ALERT SERVICE BULLETIN

206L-16-176

SUBJECT: Air Conditioner Blower Motor Connector, Inspection of

Title: SB 206-110414; Bell 206 Air Conditioner Blower Motor Connector

Figure 1 Aft Evaporator Blower Assembly S-6102EC-3 used in 206EC-200-9,-10,-11 AC kits

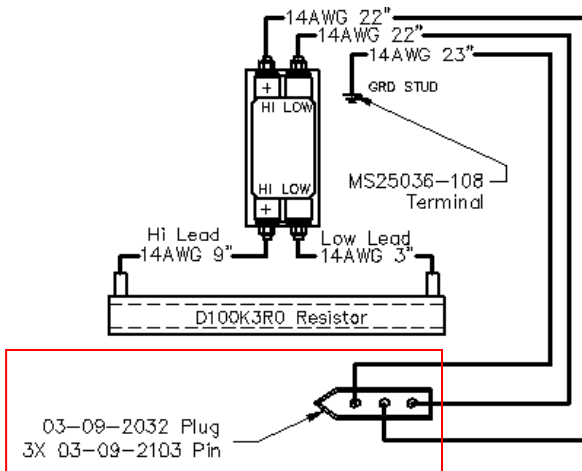
Locate each connector shown in Figures 1, 2, and 3. De-mate each connector and inspect both mates for signs of overheating, discoloration or plastic deformation. Gently pull (estimated 5-7 lb force) on each wire to verify the integrity of the contact's crimp. The contacts should be fully seated and locked in the housing so pulling gently on the wires will not dislodge the contacts from the housings.

If any signs of overheating of the housing are present or if the pull test fails, the system must be rendered inoperative and the connector housings and contacts replaced with new replacement connectors using Deutsch HDT-48-00 Crimping tool or equivalent MIL-DTL22520 Type 1 crimping tool before further operation. See Section B for information on how to contact Air Comm Corporation.

Installation instructions for new replacement connectors are per the view below and as shown on pages 6 and 7.

Figure 2 Aft Evaporator Blower Assembly S-6078EC-15 used in 206EC-212-3,-4 AC kits

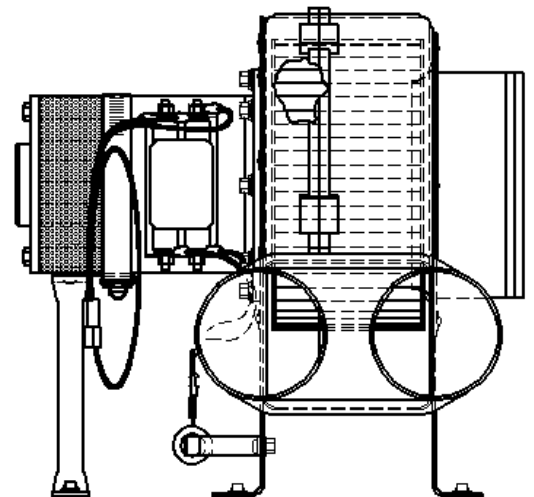
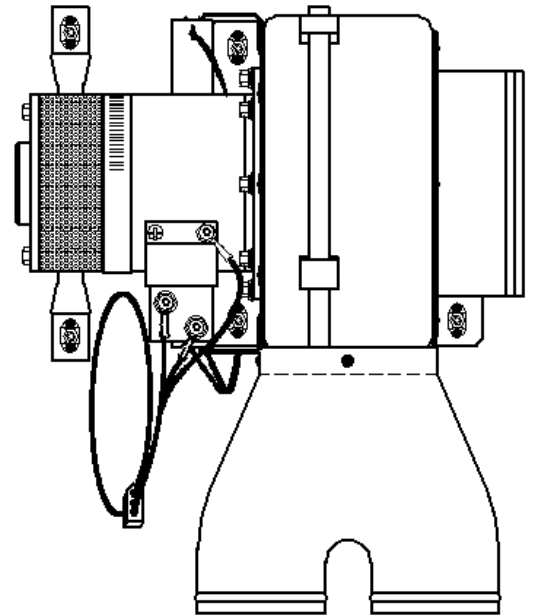
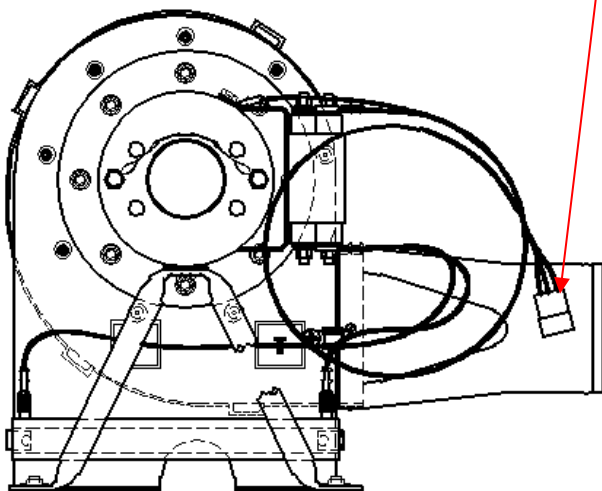
Inspect this connector.
If replacement is necessary
wire per Figure 6

Figure 3. Condenser Blower S-7060EC -1, -2 used on 206EC- 200-212 Systems

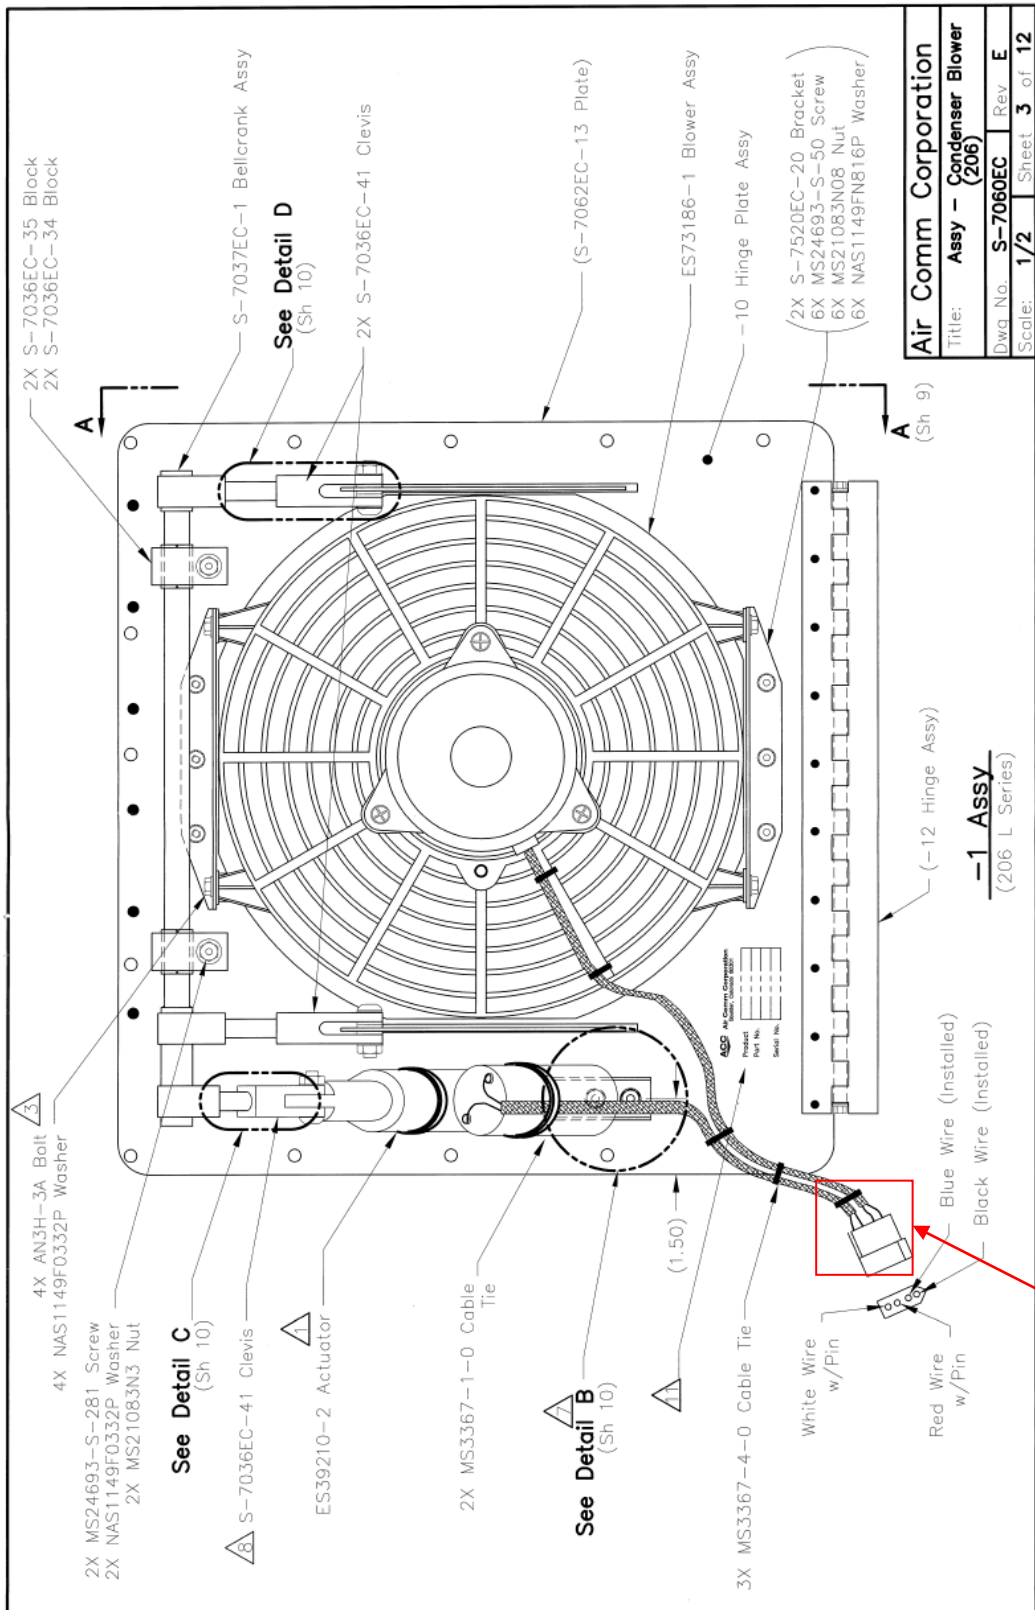
Inspect this connector

Note that the pinout of the replacement connector set is defined by the installer, however the wire alignment across the connector set must remain unchanged.
